**ADDENDUM NUMBER TWO (2)  
TO THE PLANS AND SPECIFICATIONS FOR:**

**NORTH ECHS  
AND  
COLLEGE & UNIVERSITY CAMPUS  
STUDENT RESTROOM RENOVATIONS**

**PSJA ISD  
Bid # 18-19-042  
Project No. 19.04**

**GIGNAC & ASSOCIATES  
3700 N. 10<sup>th</sup> STREET, SUITE 205  
McALLEN, TEXAS 78501  
(956) 686-0100**

**ADD. 2**  
**A-110-N**

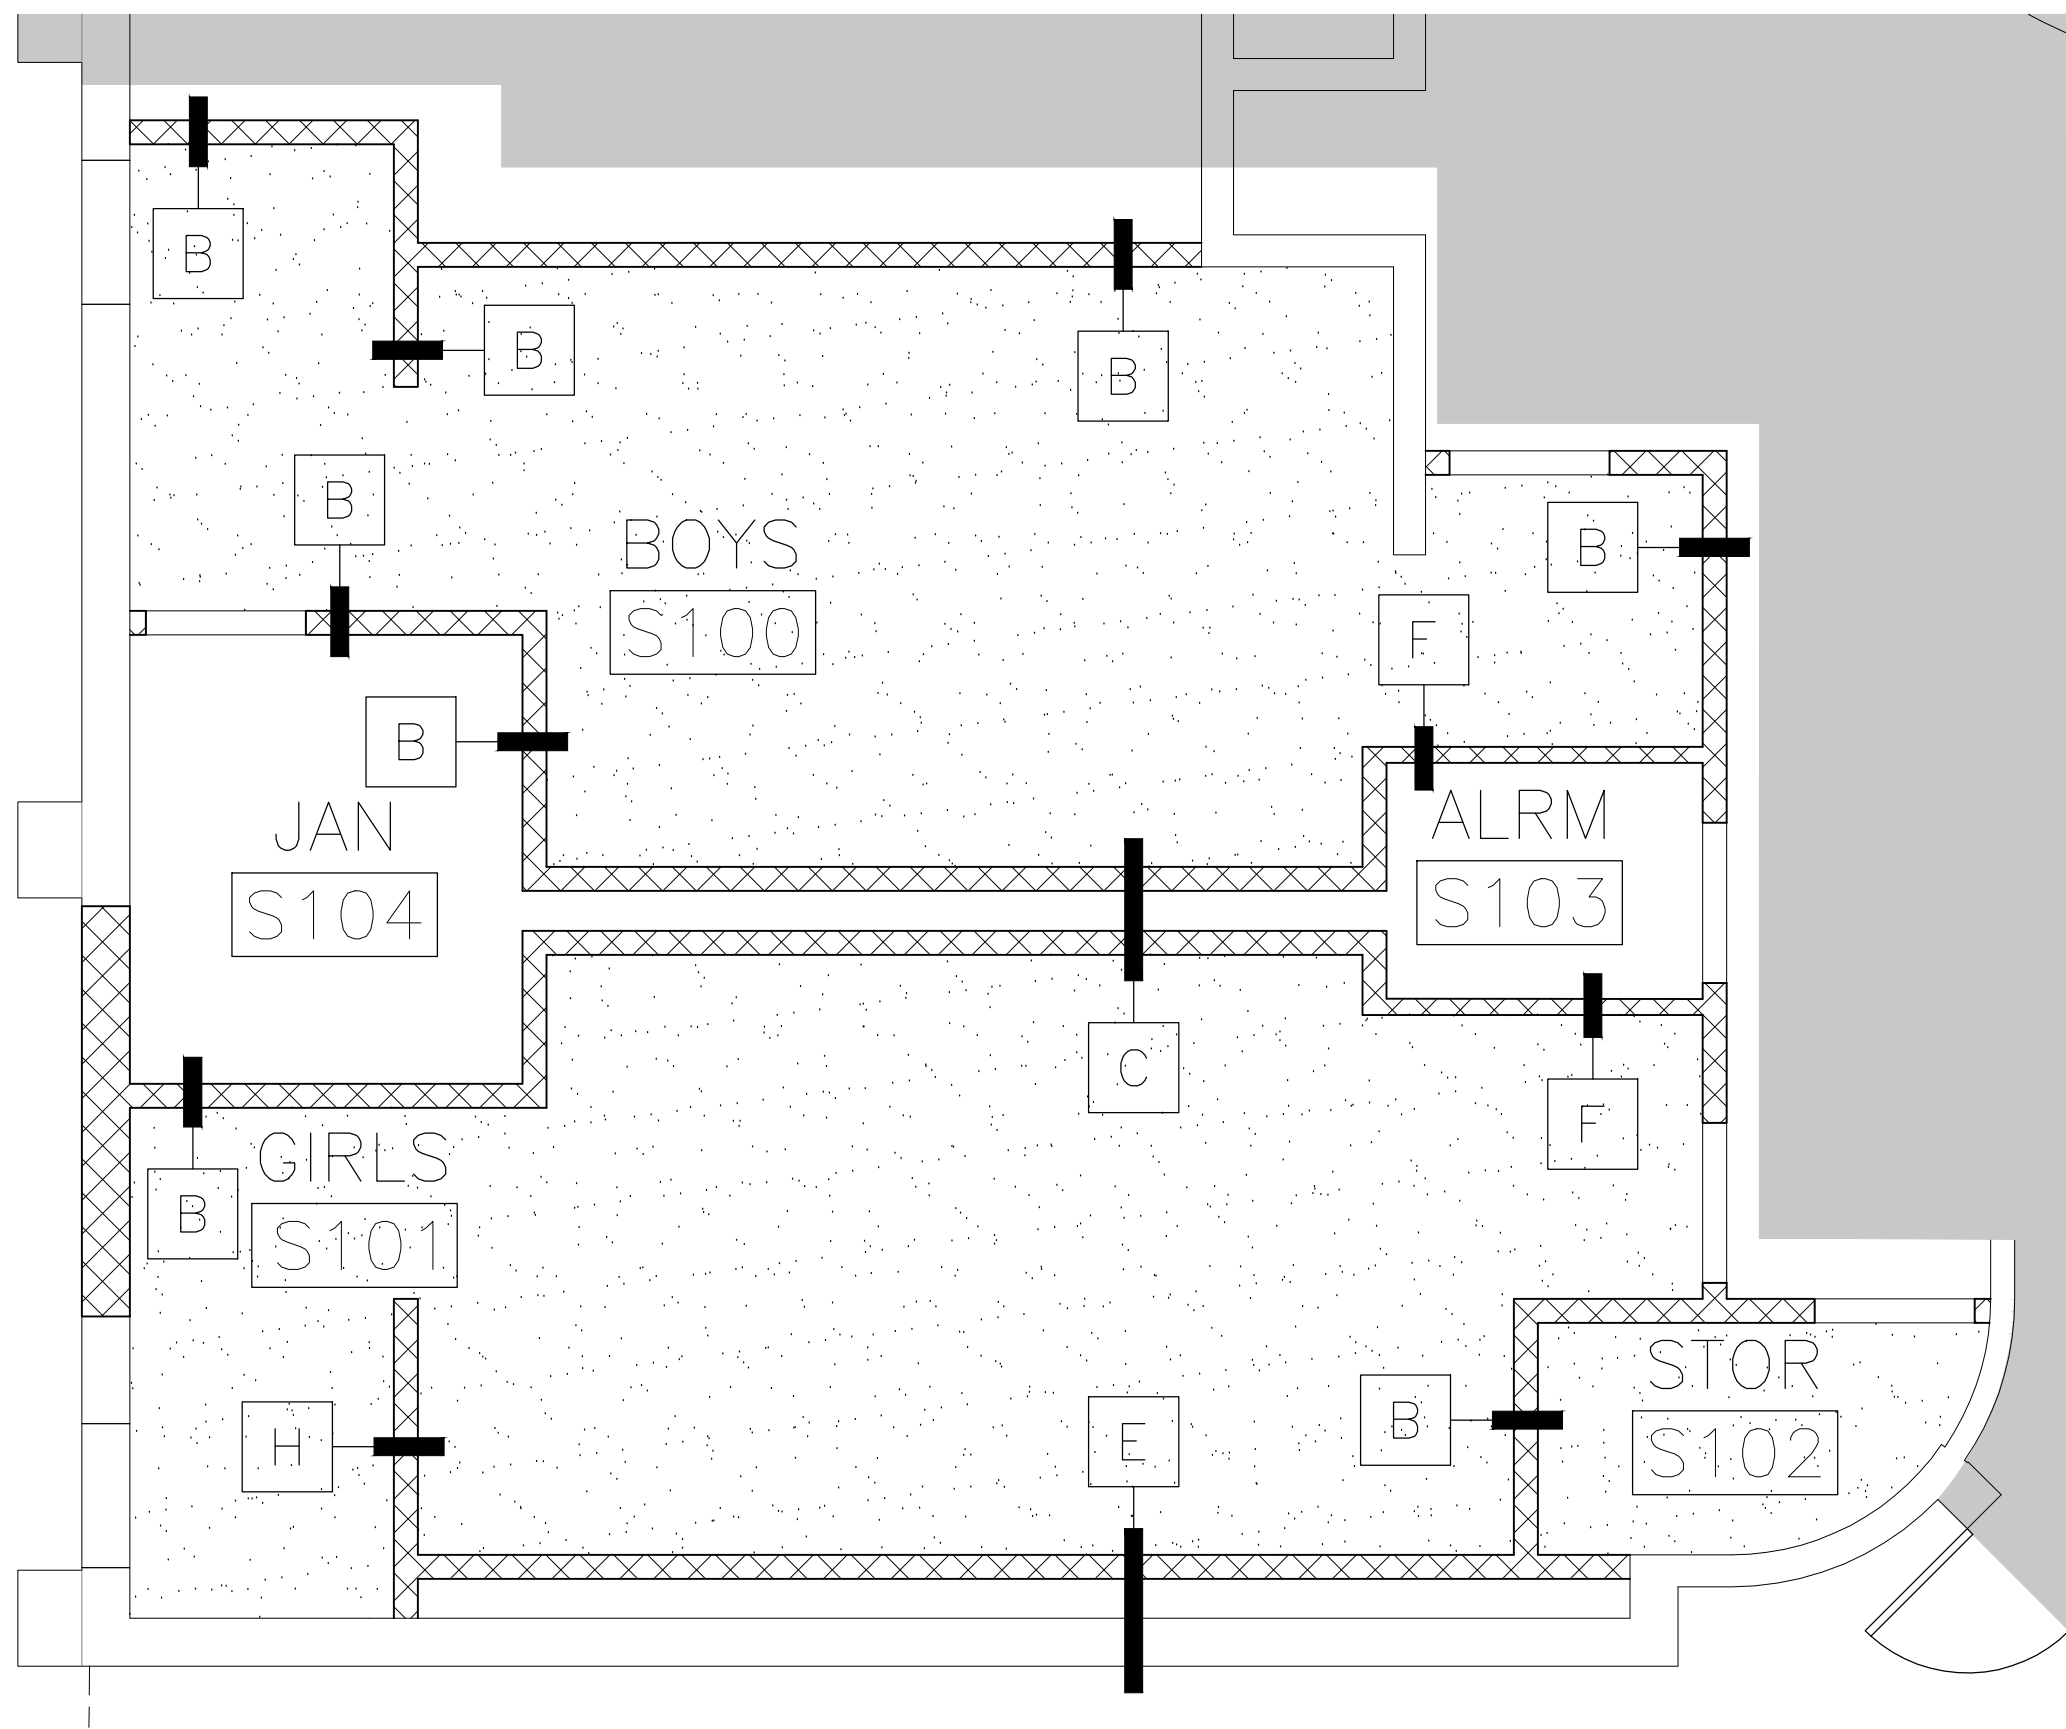
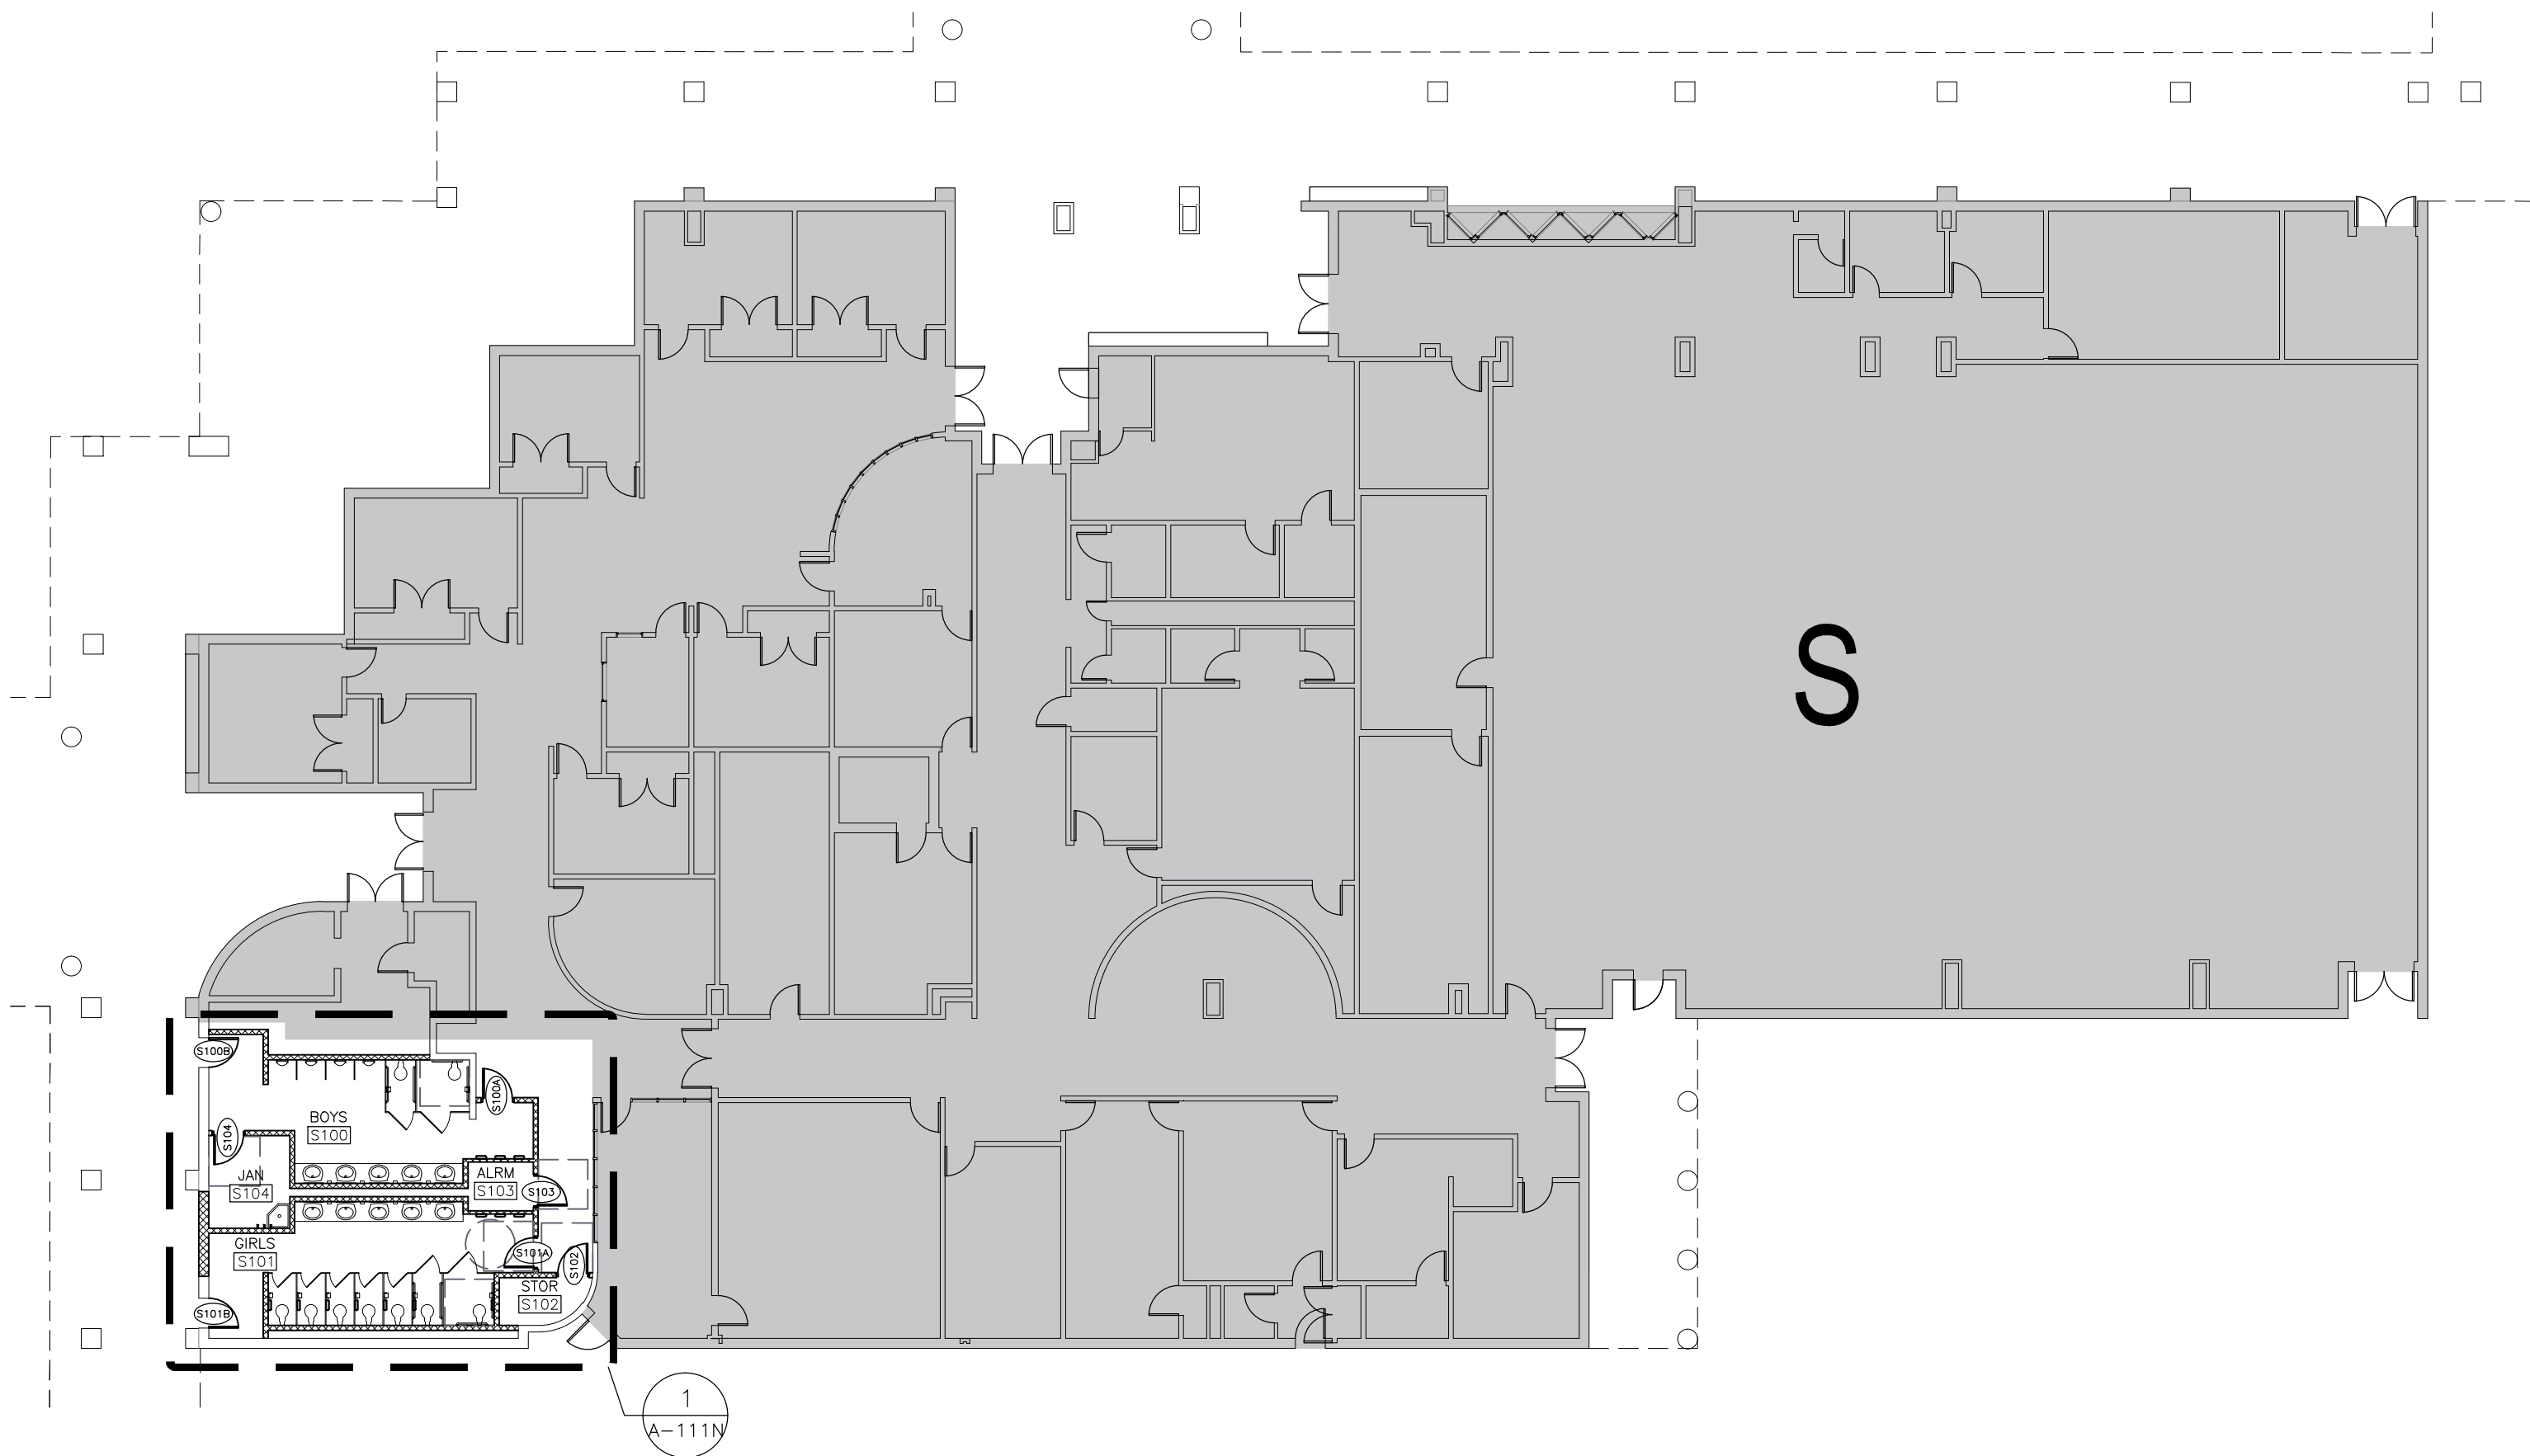
Sheets A-110-N thru A-127-N included in this Addendum shall replace their respective sheets in the Contract Documents. Further labeling, dimensions, and clarification was added.
